Special Exception Resurrection Cemetery

SE-4823

TECHNICAL STAFF REPORT:

SUBJECT: Special Exception SE-4823
Resurrection Cemetery

LANDSCAPE PLAN

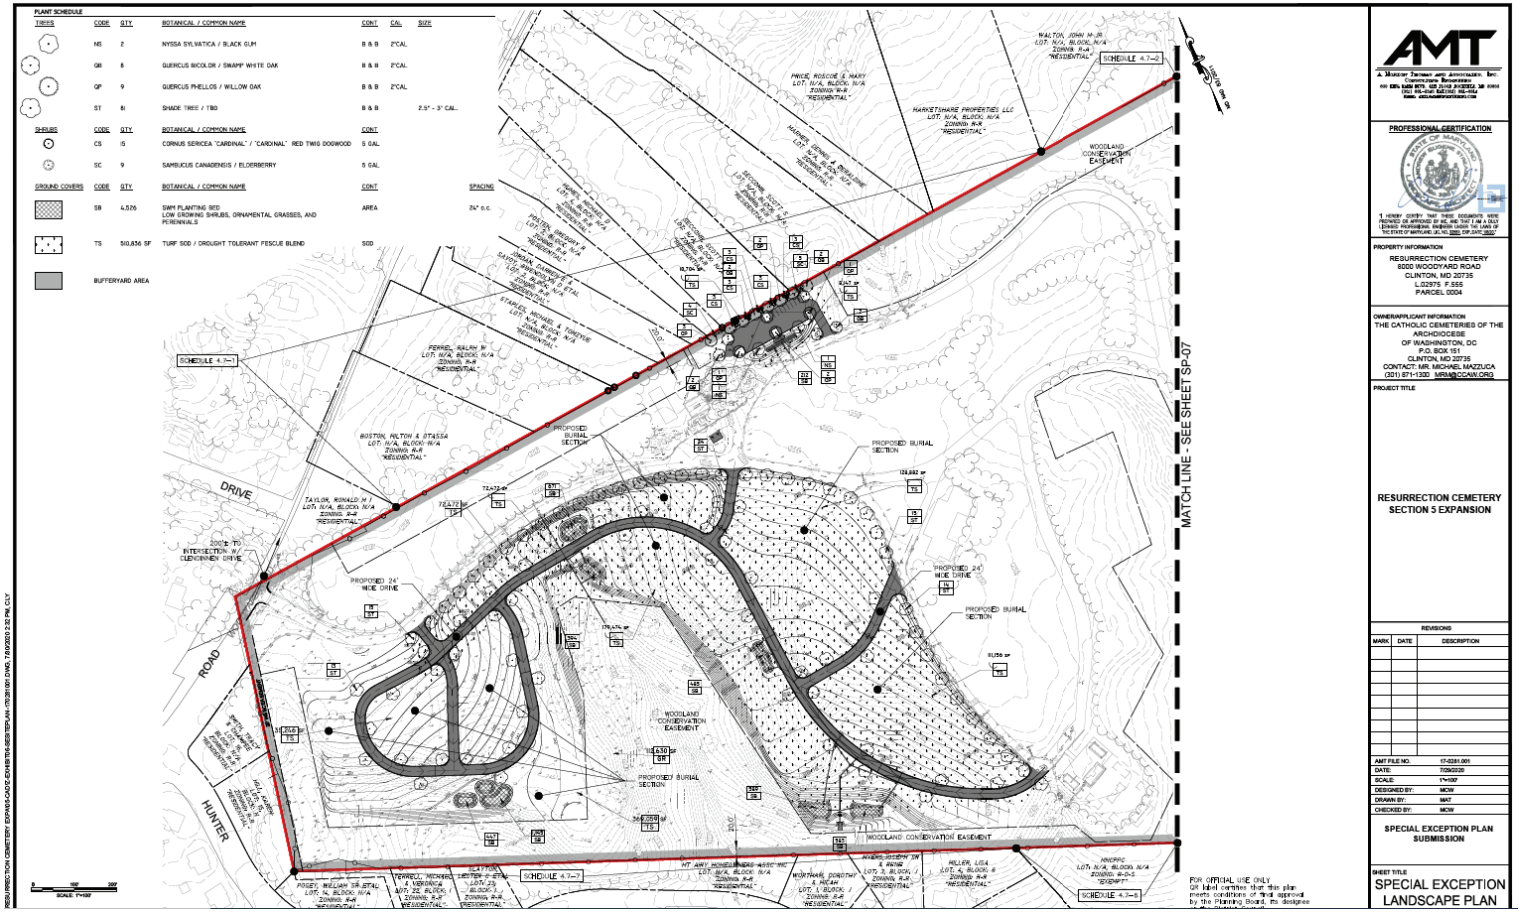
Section 4.6 of the Landscape Manual requires special roadways to be buffered from development. Woodyard Road is a designated historic roadway in the 2009 *Approved Countywide Master Plan of Transportation*. Adjacent to a historic road, the Landscape Manual, which became effective on December 13, 2010, requires a Section 4.6 landscape buffer (Buffering Development from Special Roadways) based on the development tier. Conformance to this standard shall be established prior to certification of the special exception.

Section 4.9 of the Landscape Manual promotes sustainable landscaping as an environmentally sensitive design approach. A percentage of plants within each plant type (including shade trees ornamental trees, evergreen trees, and shrubs) shall be native species (or cultivars thereof) and shall be identified on a planting schedule on the landscape plan. Any existing trees and/or vegetation retained in fulfillment of the requirements shall not contain invasive species, which must also be reflected in the schedule. Trees proposed in fulfillment of the requirements shall not be planted on slopes steeper than three-to-one (3:1). Conformance to this standard shall be established prior to certification of the special exception.

a. Provide a 2010 *Prince George's County Landscape Manual* Section 4.6 landscape buffer along Woodyard Road (buffering development from special roadway), as it is an historic roadway as designated in the 2009 *Approved Countywide Master Plan of Transportation*, and add a Section 4.6 Schedule to the landscape plan.

b. Provide a 2010 *Prince George's County Landscape Manual* Section 4.9 Schedule on the landscape plan.
